HISTORIC CONSERVATION BOARD

AGENDA

Monday, March 25, 2024 at 3:00 pm

APPLICATION #: COA2024004
APPLICANT: Robert Strunc
OWNER: Southern Ohio Housing
ADDRESS: **226 Mohawk Street**
PARCELS: 095-0002-0038
ZONING: UM – Urban Mix
OVERLAYS: Sohn-Mohawk Historic District
COMMUNITY: Sohn-Mohawk
REPORT DATE: February 26, 2024
STAFF REVIEW: Kate Meehan, Zoning Plans Examiner

01-18-24
Drawn: BS	Project No:
Sheet No.	A205

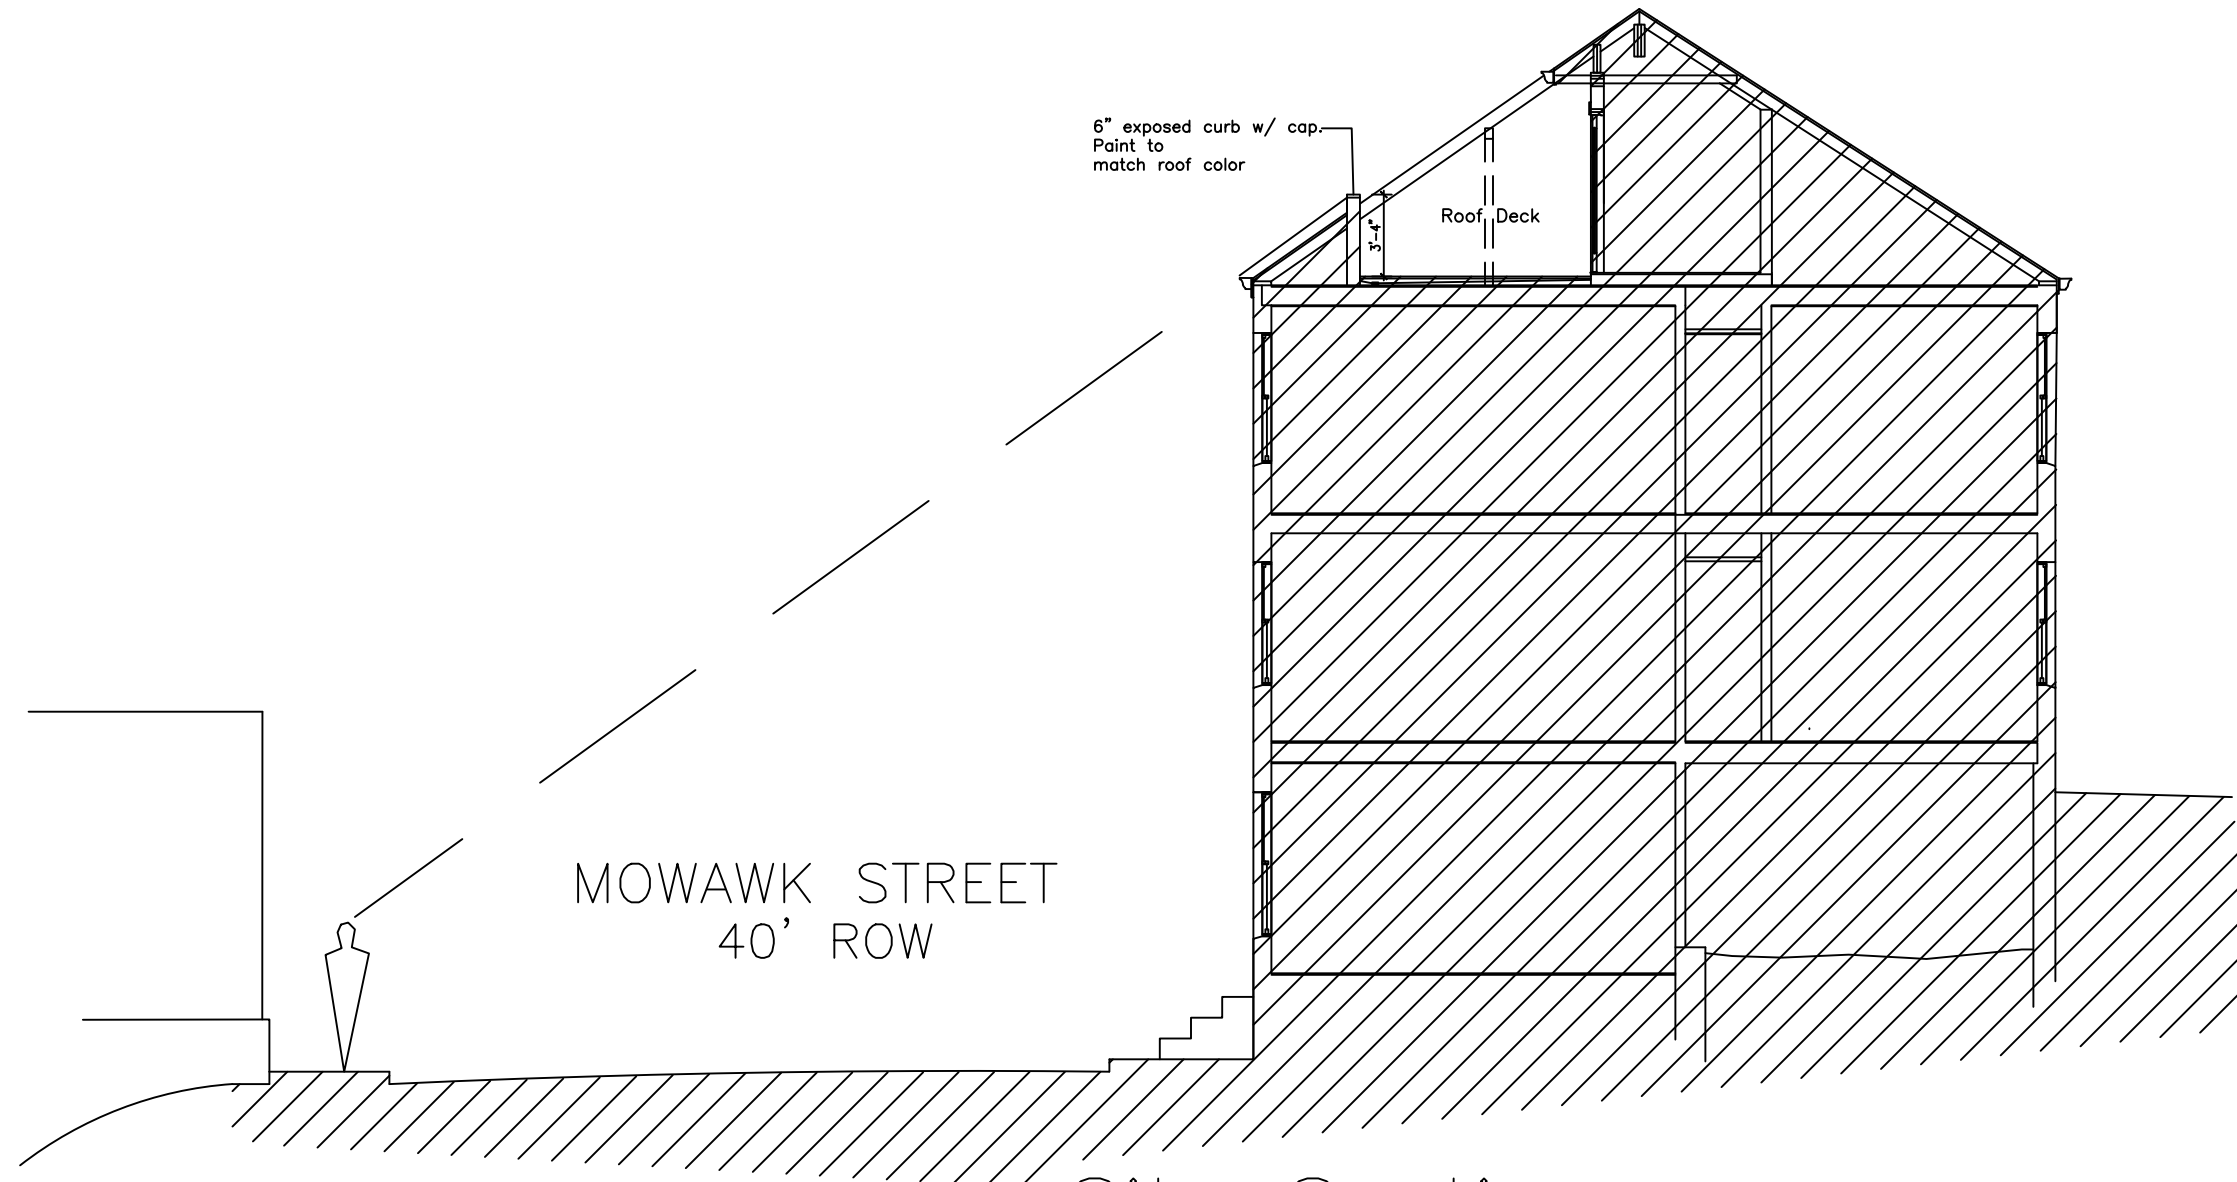
2. Recommend the guardrail is removed and the roof serves as the guardrail, or that it be pushed back 6" so as to reduce its visibility. Per the site line drawing in Figure 4, the top of the cap appears to be visible.
3. The building permits must be issued within two years of the decision date or the Certificate of Appropriateness shall expire.
